AIRWORTHINESS DIRECTIVE

Cessna 207 Series Aeroplanes

**AD/CESSNA 207/32
Amdt 2**

Forward Door Post Bulkhead

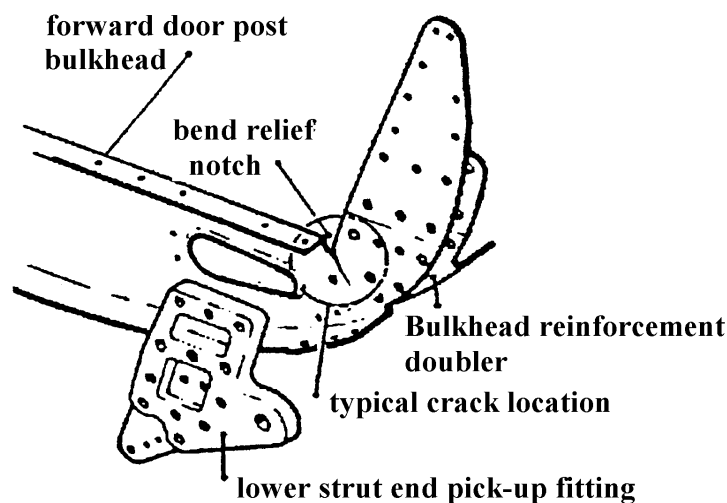
1. Visually inspect for cracks at the inside edge of the left hand and right hand bend relief notches of the forward door post bulkhead.
2. Visually inspect for loose or working fasteners securing the lower strut end pick-up fitting to the forward door post bulkhead. The inspection areas and typical crack location are shown in the diagram below.

Note 1: Inspection in accordance with Requirement 1 will initially require removal of certain floor panels. Incorporation of inspection holes in accordance with an approved modification will allow inspection of the relief notch without requiring removal of the floor panels.

Note 2: Inspection in accordance with Requirement 2 may be accomplished from outside the aircraft via the hole exposed by removing the lower wing strut fairing.
